Re: Cottonwood Classical GYM Addition & Classroom Renovation
7801 Jefferson St. NE
30-Day Temporary Certificate of Occupancy
Transportation Development Final Inspection
Architect's Stamp dated 09-17-21 (D17-D003A)
Certification dated 05-12-23

Re: Cottonwood Classical
7801 Jefferson St. NE
Traffic Circulation Layout
Architect's Stamp 9-17-21 (D17-D003A)

TRAFFIC CIRCULATION LAYOUT

TCL-001

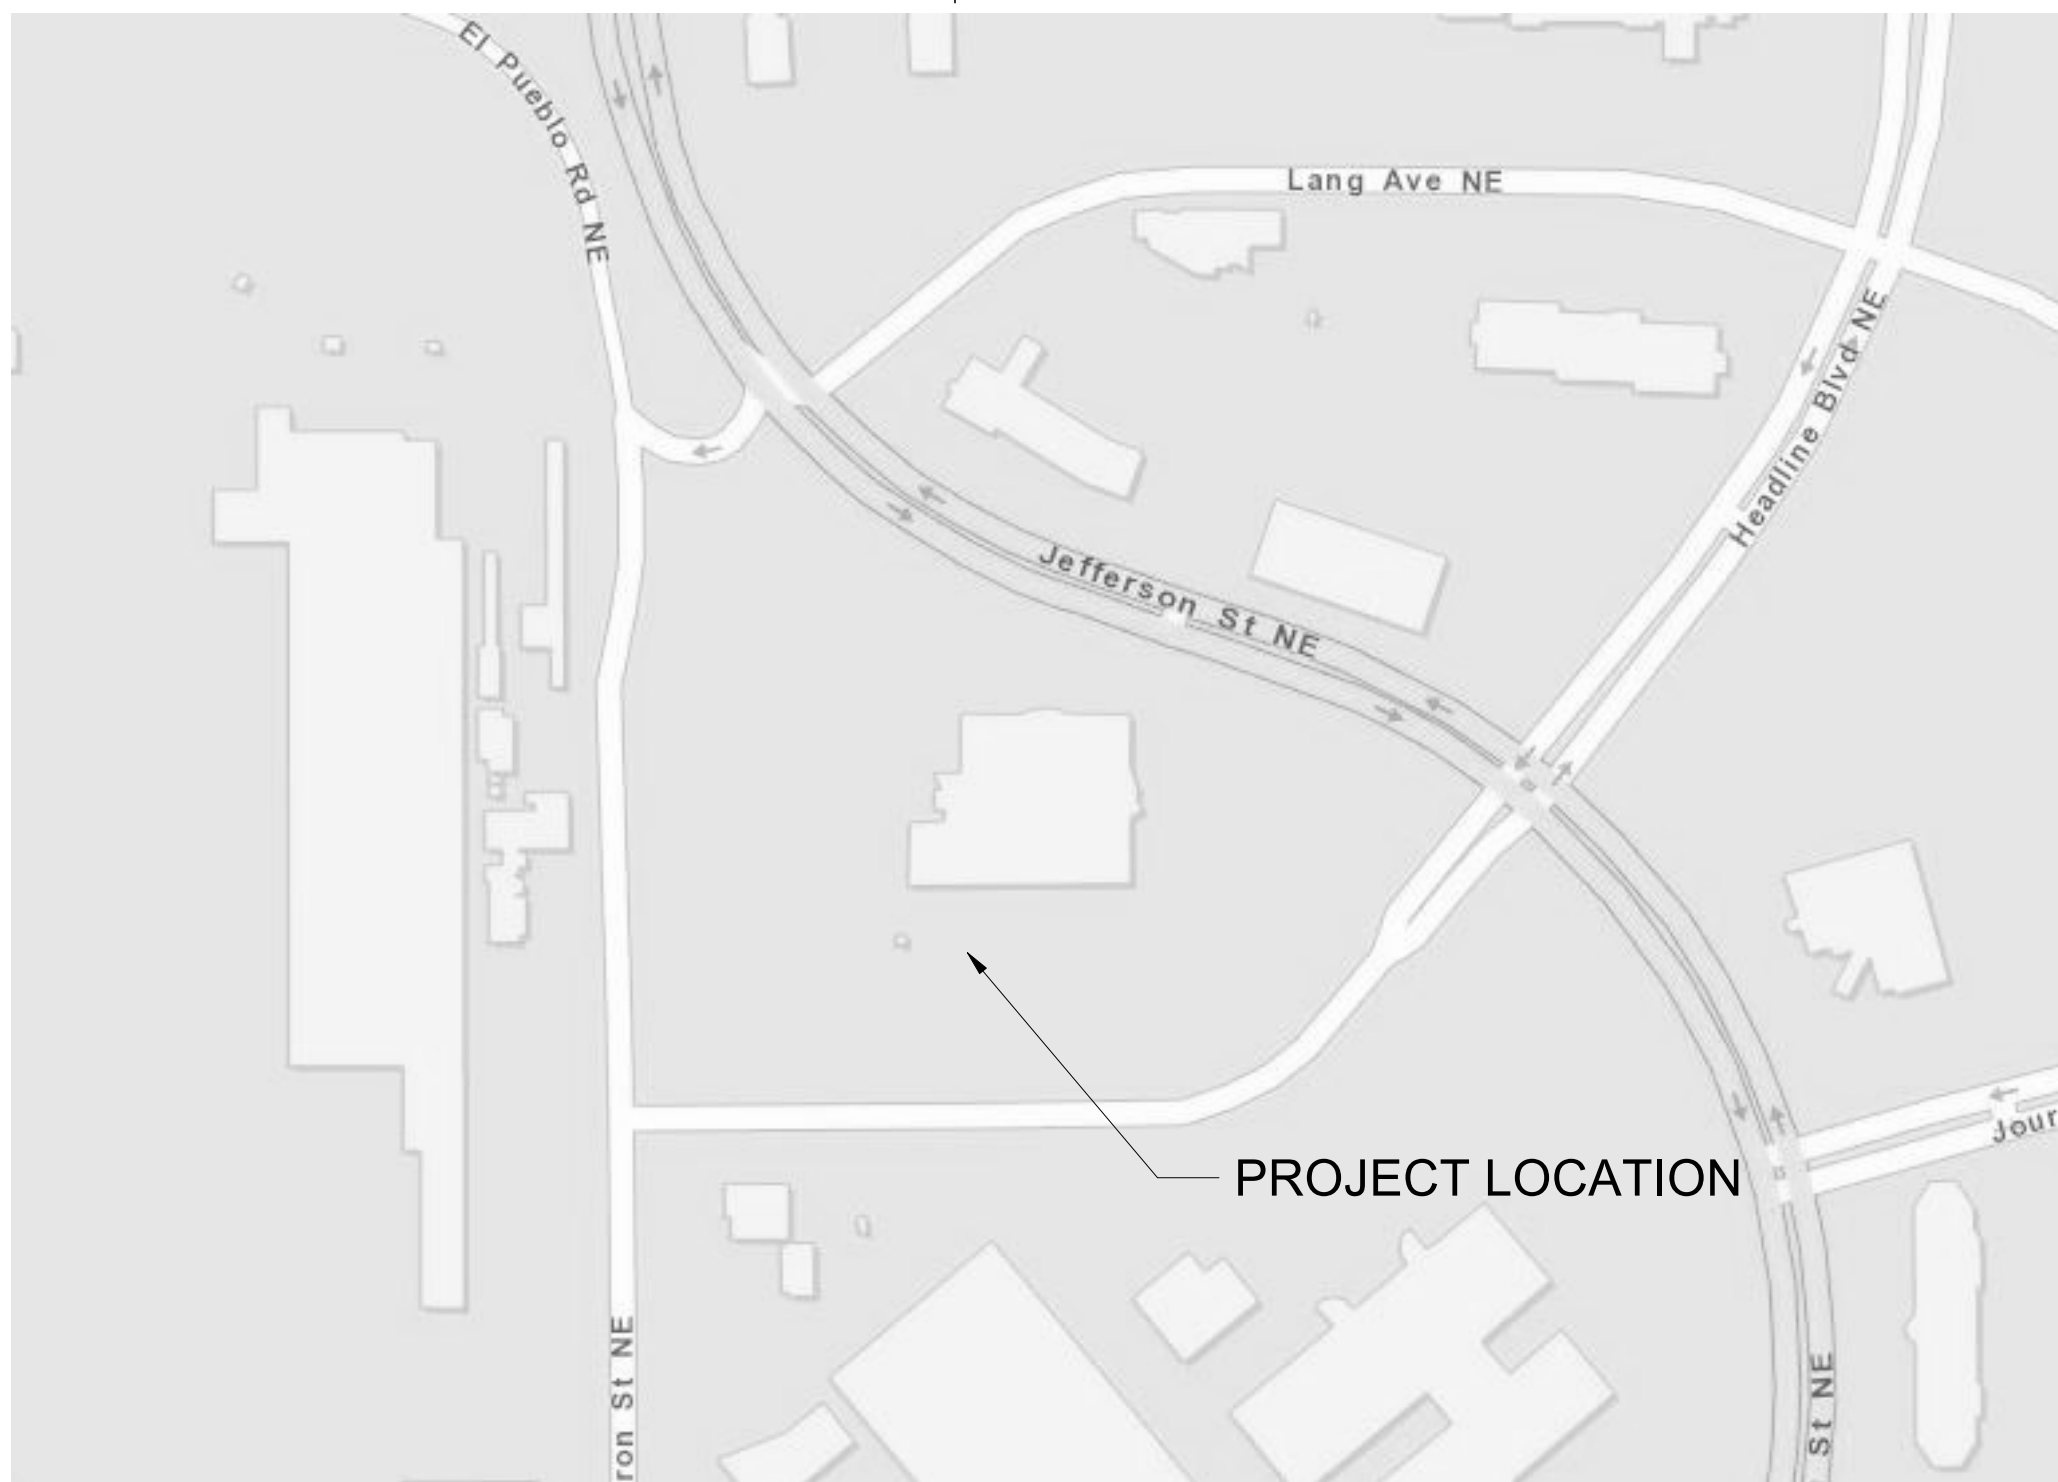
- Per approved plans, Truncated Domes must be installed on the ADA ramps at the site access off Headline Blvd. NE

Once these corrections are complete, email pictures to malnajjar@cabq.gov for release of Final CO.
